**CITY OF NEWPORT BEACH  
HARBOR COMMISSION STAFF REPORT**

Agenda Item No. 1  
October 14, 2009

**SUBJECT:** Appeal the Harbor Permit / Approval in Concept for the AERIE Dock Structure at 201-207 Carnation Avenue

### Exhibit 4 Proposed Dock Layout with Dimensions

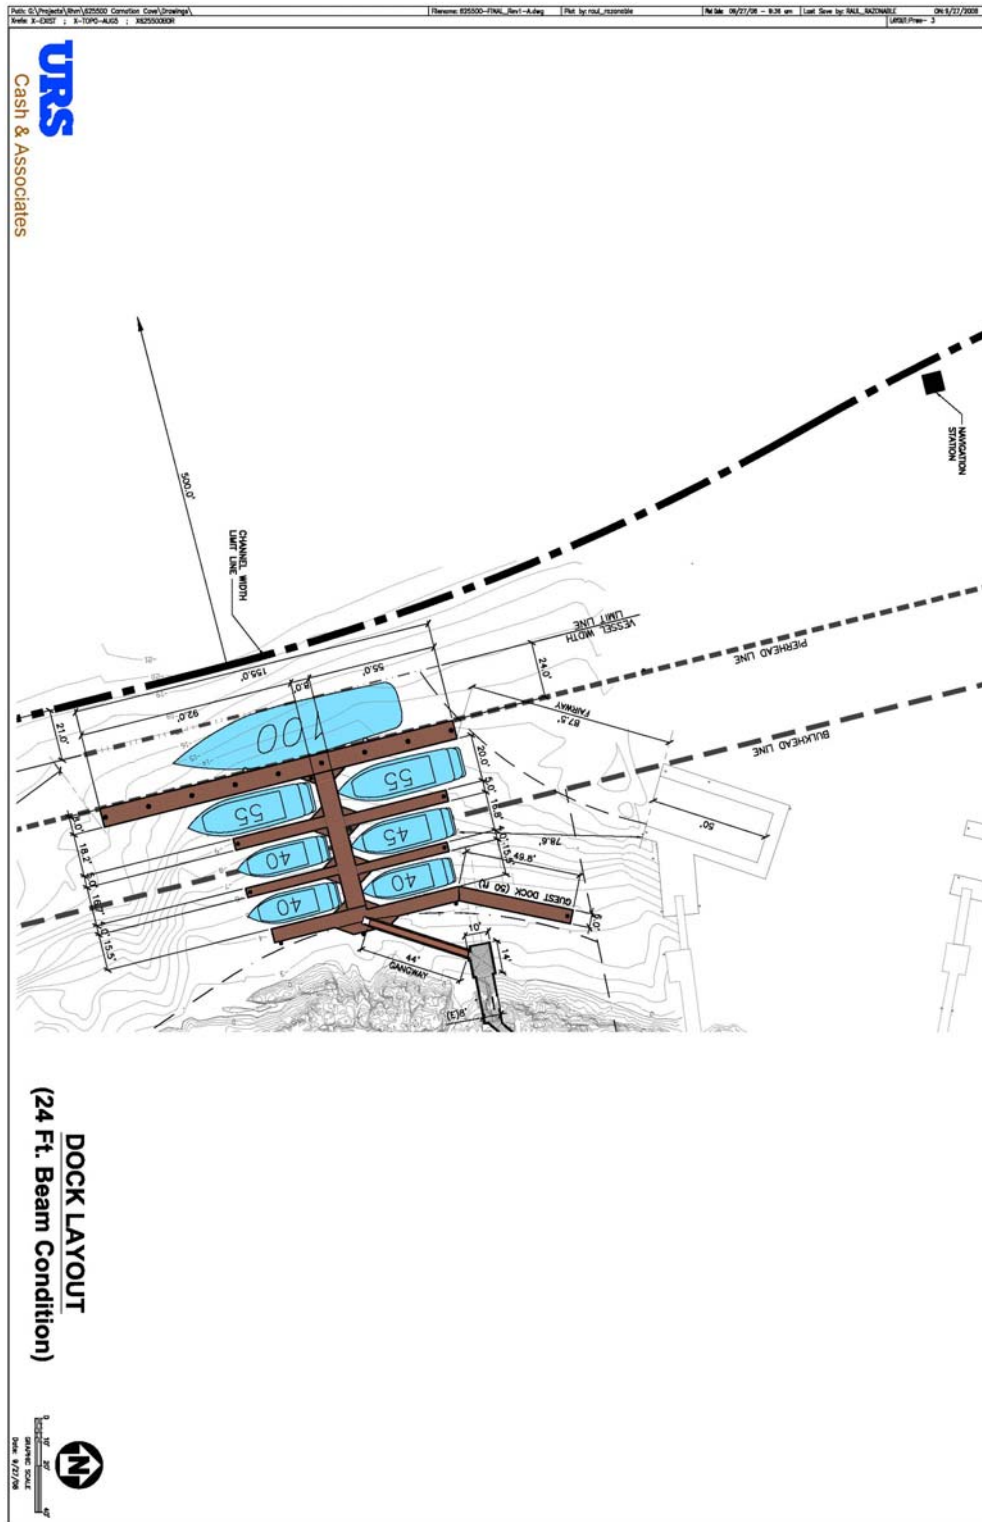
13. The vessels that will be side-tied to the outside, bayward-most float which is positioned on the Pierhead Line, shall not extend into the harbor more than 24 feet from the edge of this outside, bayward-most float. This is shown on the approved drawings as the "Vessel Width Limit Line." The vessels side tied at this location shall be safely secured to withstand various weather and ocean/bay conditions. The applicant shall also submit an Inclement Weather Action Plan to the Harbor Resources Manager that describes detailed preventative measures that will be taken with respect to the vessels during storm conditions.

**Aerie Docks Relationship to Navigation Channel & Harbor Lines**

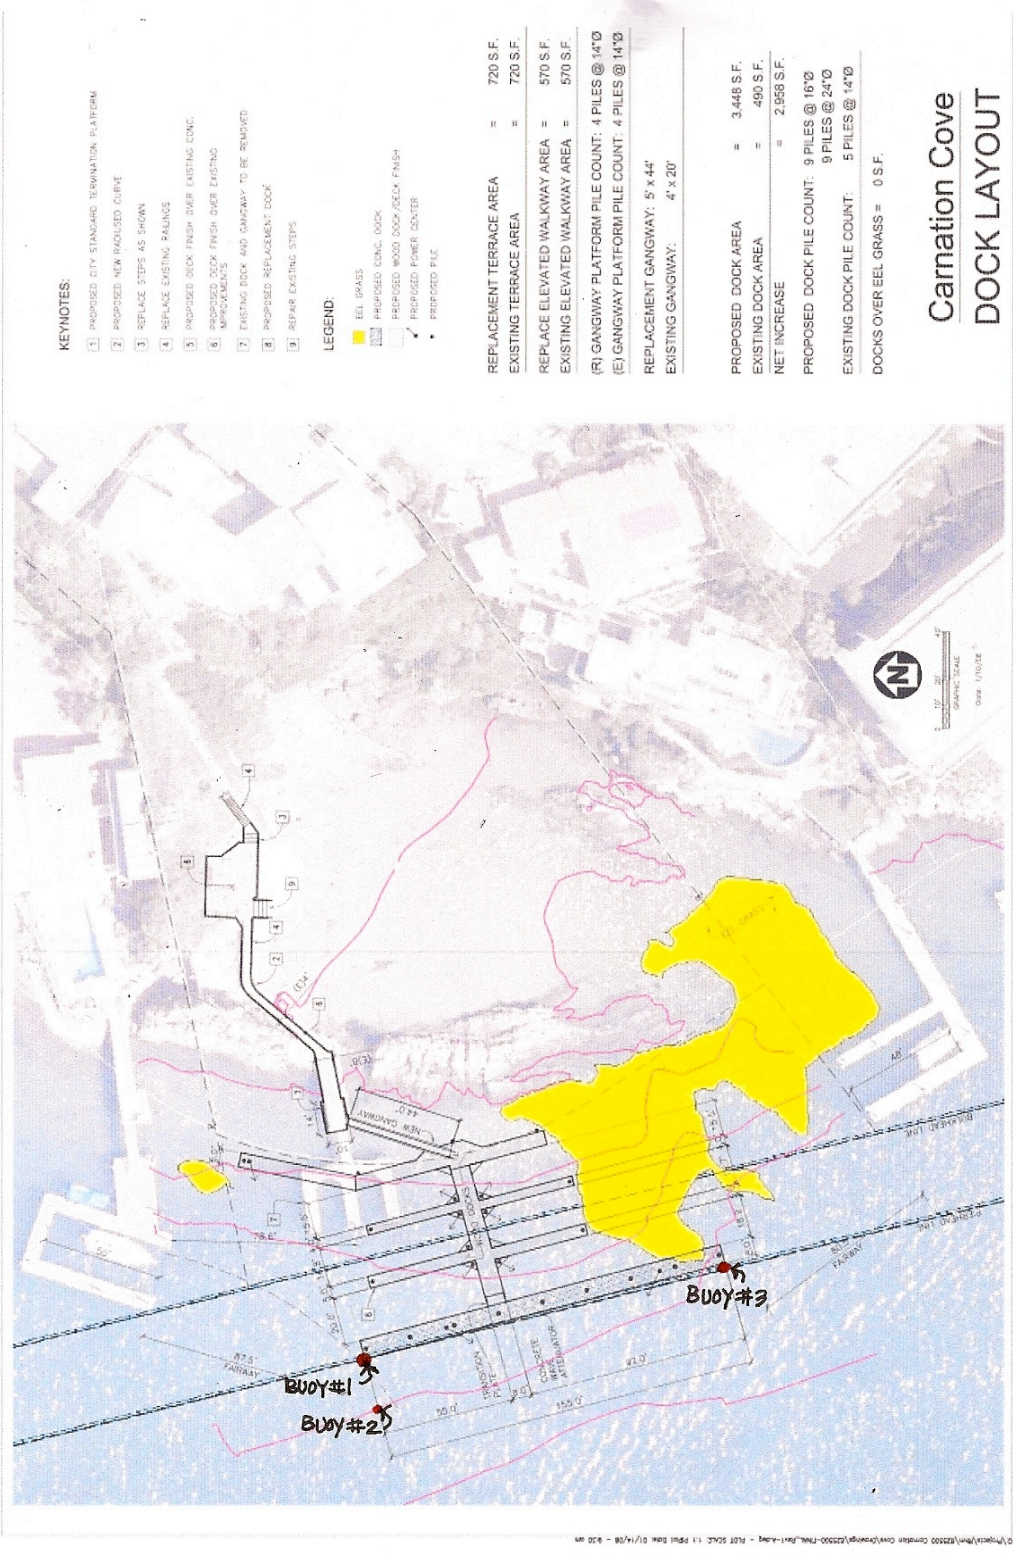
and configuration and indicates that the proposed project would not alter this use or compromise safe passage of a vessel depending on these waypoints and course.

4. The “narrowest point of the harbor” for safe/official navigational purposes is not at the project site nor is it created by the design construction and use proposed project, but rather occurs some 350’ to the North beyond the proposed project area where the R6 mark marks the bend and narrowing of the channel to the NW. Inbound vessels navigating outside the eastern edge of the navigation channel and to the east of the R6 mark will encounter the County mooring field and private docks and shoreline extending from Carnation Cove beyond which block their route and will typically turn well before the R6 mark. This continues the existing historic and typical use of the navigation channel and adjacent waters along this portion of its length and configuration and indicates that the proposed project would not alter this use or compromise the safe passage of vessels inside the navigation channel or 20’ outside of it to the east.

5. The design of the proposed docks and their berthed vessels would retain continued direct public-waters access and views to the existing beach by small beachable vessels (kayaks,etc.) and retain shallow water access and views to the bluff and the distinctive rock formation through an 88’ wide channel to the north of the docks and an 80’ wide channel to the south , both opening up to wider water areas and views as these areas are entered on passed by vessels. These design elements appear to comply with the Draft EIR and with City, State and Federal laws and requirements, as well as the spirit of community interests in preserving public access to and use of this water area, its beach and its views to the rock formation.

**The preliminary layout and design of the proposed dock system and its structural pilings appears to comply with accepted professional marine engineering practice and the recommendations of the various technical studies for a project of this type on this site. The project has accordingly received preliminary City Approval in Concept (with a number of conditions). The owner, through acceptance of these conditions, must acknowledge and assume the risk that the Newport Beach entry channel and thus docks and vessels on this site are potentially subject to potentially severe wave conditions in extreme weather events which may exceed even the storm-resistant design parameters of the docks. The owner/developer has agreed to certain operational and management procedures for the proposed docks and berthed vessels including warnings to and required vessel relocation by the vessel owners, and other procedures, in case of an impending severe storm event. This Harbor Commission Subcommittee remains concerned that these requirements are sustained in place and continuously documented/updated subsequent to any construction of this project, and that the owner/operator properly insures, maintains and operates this project in compliance with the continuing requirements attached to its Approval in Concept. Future Harbor Commissions, Harbor Resources and City staffs should track this.**
